AGENDA
CASCADE CHARTER TOWNSHIP PLANNING COMMISSION
MONDAY, July 7, 2025
6:00PM
2870 JACKSMITH AVE SE

STAFF REPORT: Case # 25-3890
REPORT DATE: July 2, 2025
PREPARED FOR: Cascade Charter Township Planning Commission
MEETING DATE: July 7, 2025
PREPARED BY: Andrea Hendrick, Community Planning & Development Director

STAFF REPORT: Case # 25-3888
REPORT DATE: July 2, 2025
PREPARED FOR: Cascade Charter Township Planning Commission
MEETING DATE: July 7, 2025
PREPARED BY: Andrea Hendrick, Community Planning & Development Director

PHOTOMETRIC PLAN
 SCALE: NTS

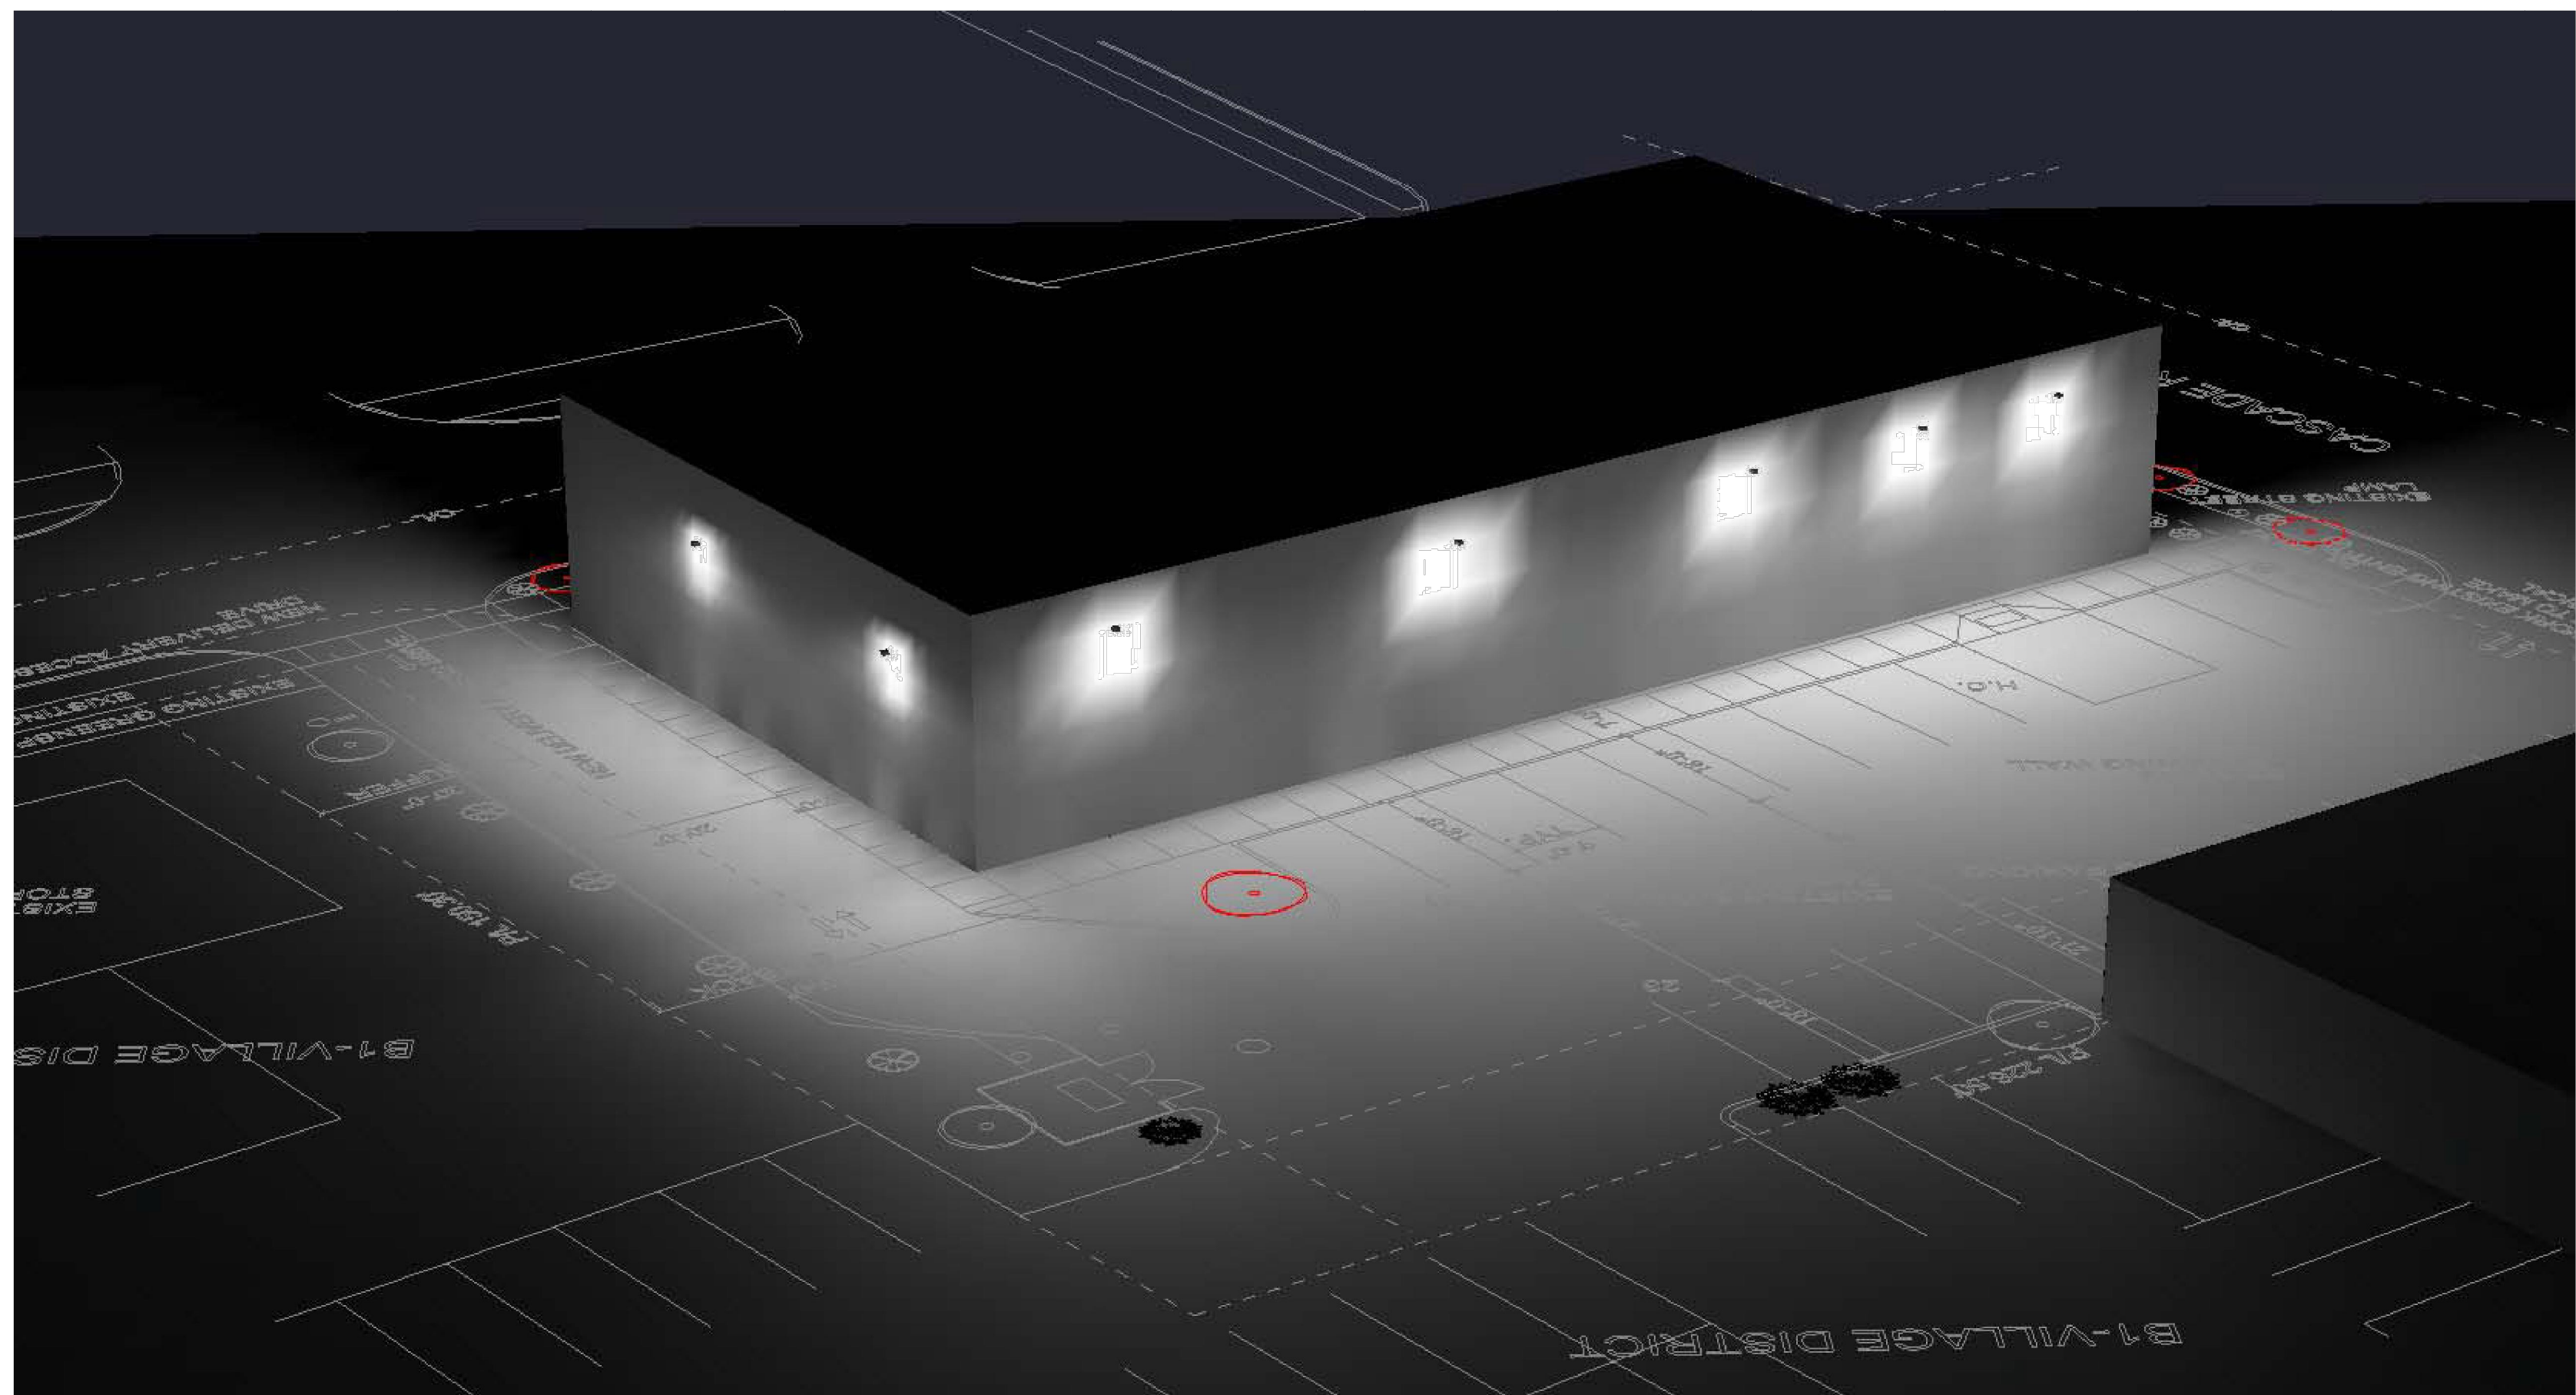
| <p>A. Lighting. Light fixture design must be approved by the Planning Commission as part of the Site Plan Review Process, and shall meet the requirements of Article 12, except for the follow requirements and allowances, which shall supersede Article 12.</p> <ul style="list-style-type: none"> 1. No freestanding light fixture shall exceed 12 feet in height. 2. Light fixture design shall be evaluated against the Architectural | <p><i>The applicant has provided a compliant lighting photometric plan. However, staff will confirm that the calculations of the lighting levels of the proposed electrical pole with site lighting on the north side of the property are included in the photometrics. If so, the lighting levels will need to be recalculated in advance of the zoning review during a building permit application.</i></p> <p><i>Additionally, uplighting is proposed and may be allowed under the provisions of subsection 4.</i></p> |

1. The VLT levels of the windows be approved by the Planning Department in advance of a building permit.
2. All lighting on site shall be calculated in the photometric and reviewed and approved by the Planning Director.
3. Lighting levels meet the requirements of Article 12.
4. The site shall be connected to water and sewer in compliance with Chapter 313 of the Cascade General Code.
5. An updated Storm Water & Sewer Maintenance Plan be recorded and provided to the township
6. **[IF EXCLUDED in provision 2]** The wood grain composite trim shall be replaced with an approved material for a Main Street Style Building Design.
